St. Lucie Unit 1
Docket No. 50-335
Proposed License Amendment
Boric Acid Makeup Tank Minimum
Inventory Requirements

ST. LUCIE UNIT 1 MARKED-UP TECHNICAL SPECIFICATION PAGES

FIGURE 3.1 - 1 ST. LUCIE 1 MIN BMT VOLUME

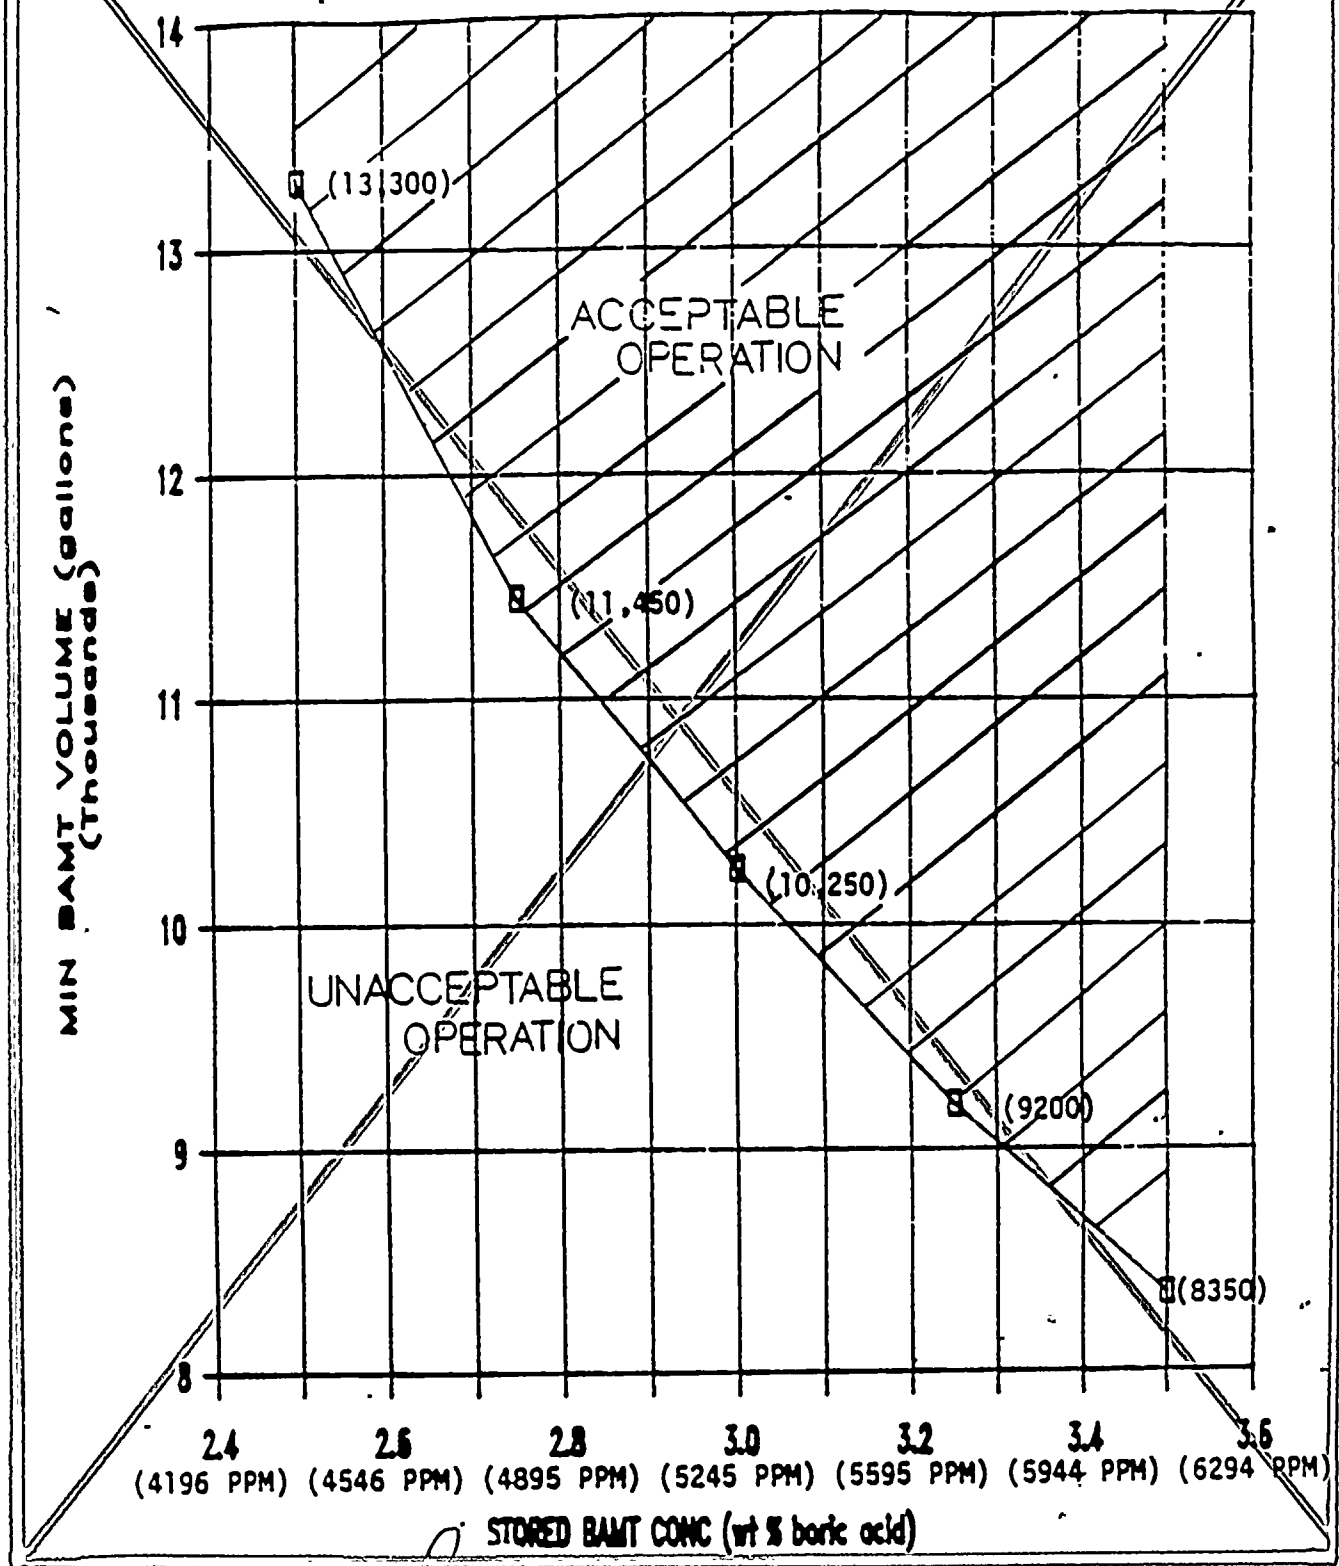
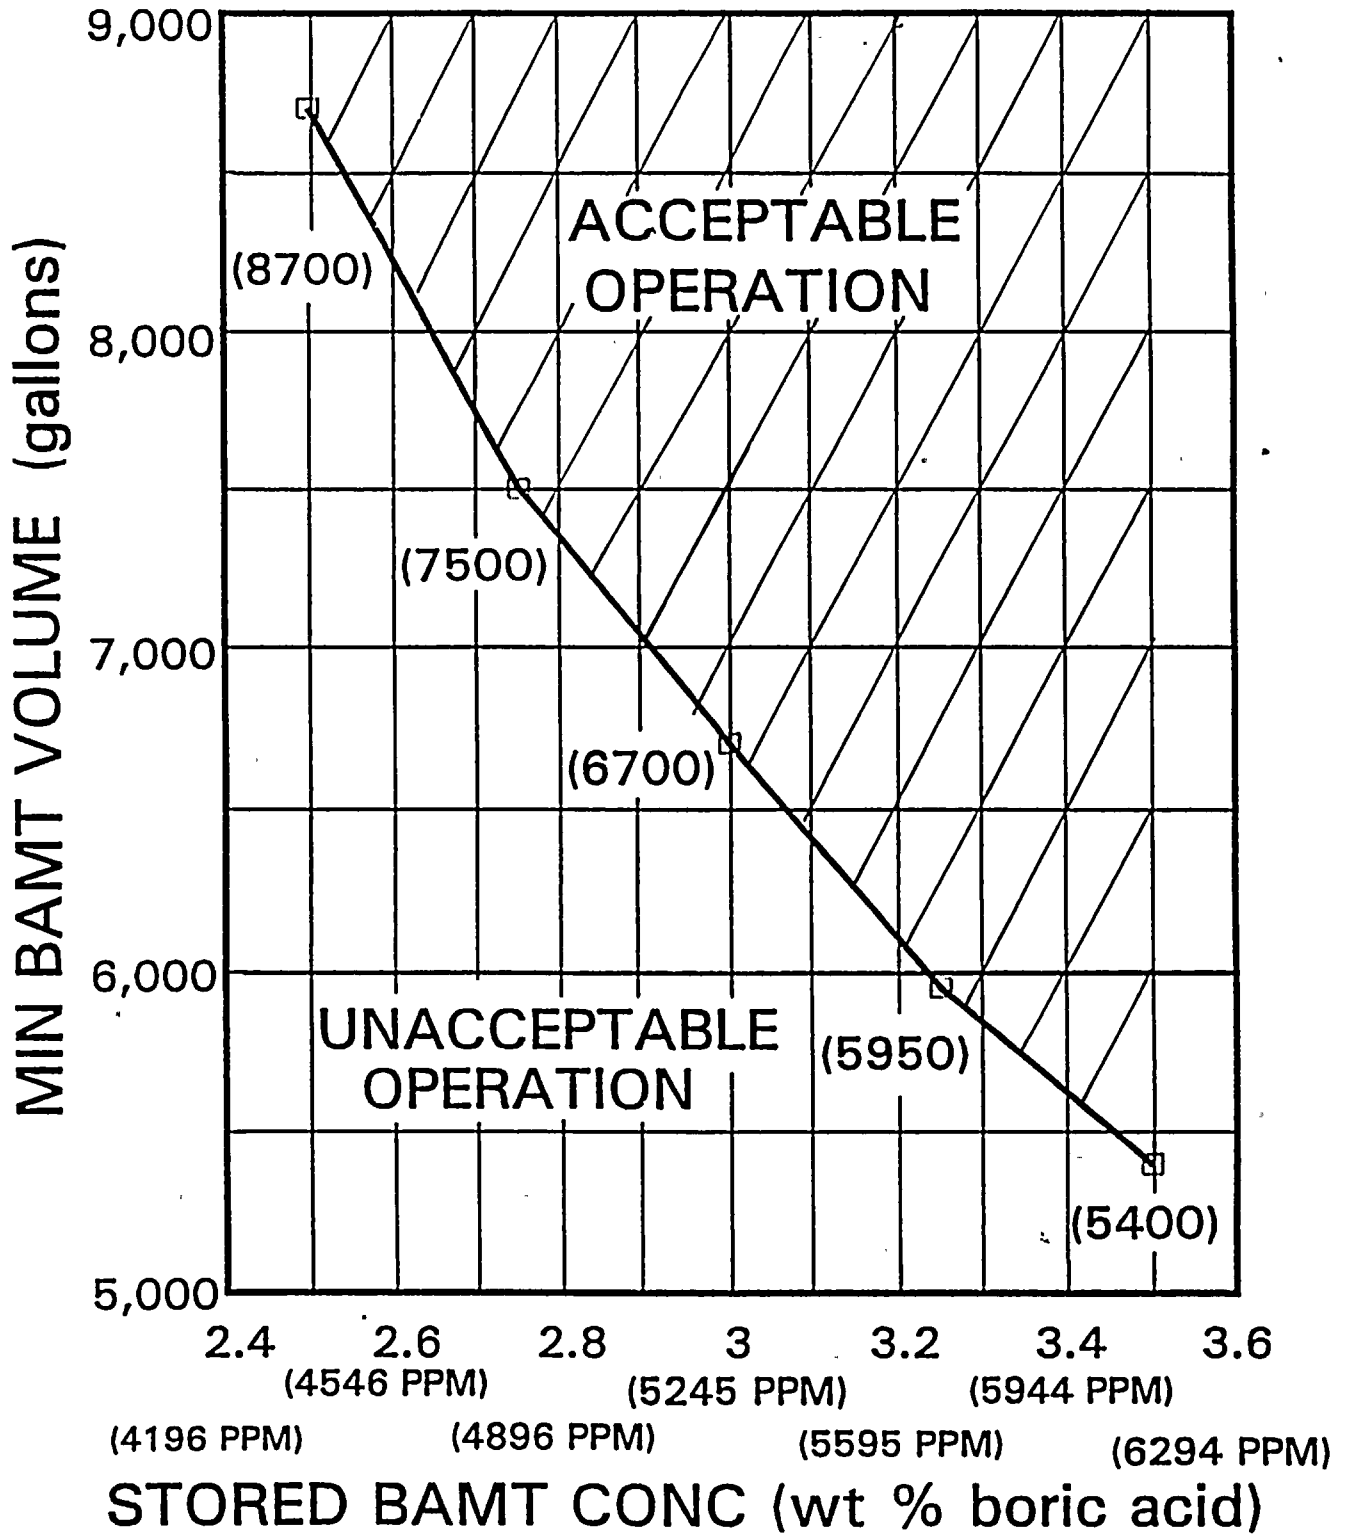
REPLACE WITH
INSERT - A
FROM NEXT PAGE

TS Figure 3.1-1, "St. Lucie 1 Minimum BAMT Volume vs. Stored BAMT Concentration," is revised to reflect a reduced volume requirement corresponding to the existing range of boric acid concentrations.

Available Borated Water Inventory (Figure 3.1-1): The reduction in required RCS boron concentration facilitates a reduced inventory of stored borated water in the makeup system. Additional BMT inventory reductions were possible by increasing the makeup water provided by the RWT during the plant cooldown scenario. Assuming no change in the approved range of stored boric acid concentration of 2.5 - 3.5 wt% in the BMTs, the amount of boration that will satisfy the RCS requirements was determined. Conservative assumptions were utilized to maximize the boration demand. These

**FIGURE 3.1-1 ST. LUCIE 1 MIN BAMT VOLUME
VS STORED BAMT CONCENTRATION**

INSERT -A

The minimum volume of borated water stored in the BAMTs is proposed to be reduced from the range of 8,350 - 13,300 gallons to the range of 5,400 - 8,700 gallons for Modes 1 through 4. The corresponding range of stored boric acid concentrations in the BAMTs is 3.5 - 2.5 wt%, respectively. This range of concentrations is the same as previously approved by Amendment No. 94 to the Unit 1 Facility Operating License.
